21 June 2022  
Our Ref: 20323A.5AJC

**RE: REQUEST FOR INFORMATION DEVELOPMENT APPLICATION NO: DA2021/2173  
ALTERATIONS AND ADDITIONS TO A SURF LIFE SAVING CLUB  
394 BARRENJOEY ROAD, NEWPORT**

Figure 2 Extract from Drawing 013 of Proposed Section B

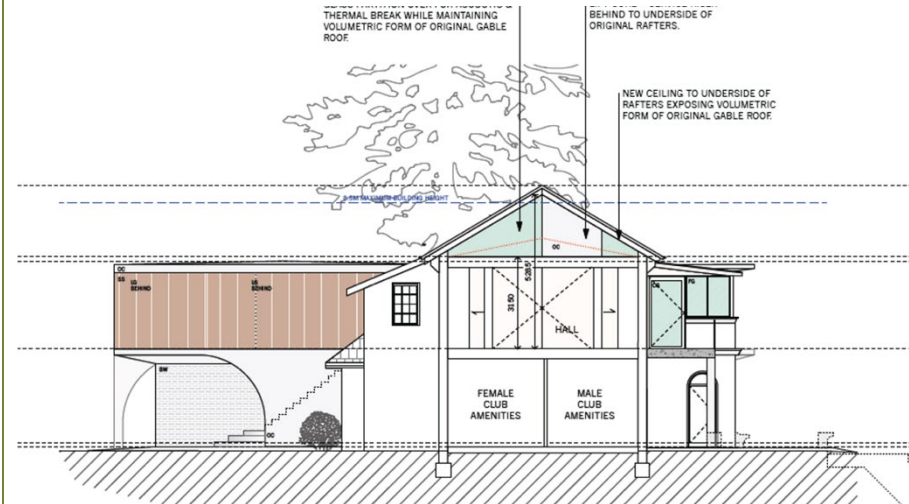
Removal of the original volumetric form of the upper-level Hall is unacceptable, given that the CMP identifies this as fabric of high significance. This adverse impact is therefore not supported. Furthermore, the SoHI does not assess the impact of the removal of original fabric and does not assess the loss of heritage significance.

**Recommendation 2:** Replan the upper-level portion of the proposed works so that the volumetric form of the Hall is retained. Consider relocating the lift and toilets so that the proposed addition retains the heritage significance of the place.

Table 1: Response to RFI letter dated 12 April 2022	
Matter	Response
<p><b>Heritage Issues</b></p> <p>Council has commissioned an independent Heritage Review of the proposed development by PTW Architects, which is attached to this correspondence.</p> <p>In summary, the review concludes that the proposal cannot be supported for the following reasons:</p> <p><b><u>6.2 Recommendations</u></b></p> <p><i>An assessment of DA2021/2173 is not supported in its current form. This is confirmed in the tabulations of inadequacies identified under Sections 3 - 5 of this report, including the previous commentary.</i></p> <p><i>While this report supports in principle the need to provide additional storage space and to modernise the public change rooms, along with a need to improve operational and economic viability of the club, the proposed alterations and additions to Newport Surf Club, a local heritage LEP item, has adverse heritage impact. This impact is not adequately assessed in the supporting SoHI document.</i></p> <p><i>DA2021/2173 therefore cannot be supported on heritage grounds as confirmed by the following three reasons (refer Figure 11):</i></p> <p><b><u>1. Inadequate visual and physical separation between the old and new</u></b></p> <p><i>The proposed addition with a new eaves line and projecting west facing wing, do not satisfactory distinguish the old from the new. This adverse impact is therefore unacceptable.</i></p> <p><b><u>Recommendation 1A and 1B:</u></b> Amend the design so that the proposed eaves line is more sympathetic in detail and that the projecting two storey west facing wing is positioned further away from the historic item. To the proposed addition: provide an</p>	<p>A copy of the independent Heritage Review prepared by PTW Architects (dated March 2022) has been reviewed by APA and the heritage consultant (Heritage 21) including the recommendations outlined in Section 6.1 of the review.</p> <p><b><u>Recommendations 1A and 1B</u></b></p> <p>The design of the proposed addition has been amended so as to create a clear distinction between the old and the new. A 1.35m wide glass link is provided between the existing SLSC building and the new addition (<b>Figure 1</b>). This includes a new glazed roof above the Committee Room.</p>  <p><b>Figure 1</b> Extract from Drawing 014 Proposed Elevations (APA)</p> <p>A vaulted gable roof with concealed gutters and no eaves is provided above the Committee Room. Materials and finishes of the proposed extension have been amended to further distinguish the old and the new including use of standing seam Colorbond roof over the Committee Room and Lounge areas.</p> <p><b><u>Recommendation 2</u></b></p> <p>In order to retain the 'volumetric form' of the original first floor hall, the existing false ceiling is to be removed and a new ceiling is to be installed to the underside of the rafters (<b>Figure 2</b>).</p>

The Statement of Heritage Impact (SoHI) prepared by Heritage 21 has been updated to provide the following assessment against Policy 31 (Internal Layout) of the amended Conservation Management Plan (CMP):

*The modifications to the first floor involve relocating the existing amenities to the central area of the hall. This relocation of amenities was deemed crucial to allow these facilities to be accessed simultaneously by people using the Committee Room or Hall. The area of the hall is considered to be of high significance as it retains its original volumetric space and features unobstructed view lines to the ocean. However, there has been numerous renovations which have resulted in the loss of original fabric, notably the floorboards and ceiling which were installed in 2007. It is acknowledged that this relocation of services would disrupt the volumetric space of the hall and its original layout. However, in order to minimise the impact,*

Table 1: Response to RFI letter dated 12 April 2022	
Matter	Response
	<p><i>it is proposed to remove the existing, later addition plasterboard ceiling of the hall. This would result in vastly increased space from floor to ceiling. The partitions for these new rooms would be light weight, reversible and would not extend to the rafters in order to retain this newfound space. Whilst these works would have an impact, Heritage 21 is of the opinion that a sympathetic solution has been found which is still able to attain club requirements.</i></p> <p><u>Recommendation 3</u> The SoHI has been updated to assess the amended proposal.</p> <p>The CMP has been updated to identify moveable heritage (such as photographs, honour rolls and part of row boats) located within the existing Newport SLSC building (Appendix A of the CMP). Recommendations are provided in the CMP relating to conservation management strategies for items of moveable heritage. Figures 127 and 128 of the CMP identify potential general locations on the ground floor and first floor for the display of moveable heritage.</p>
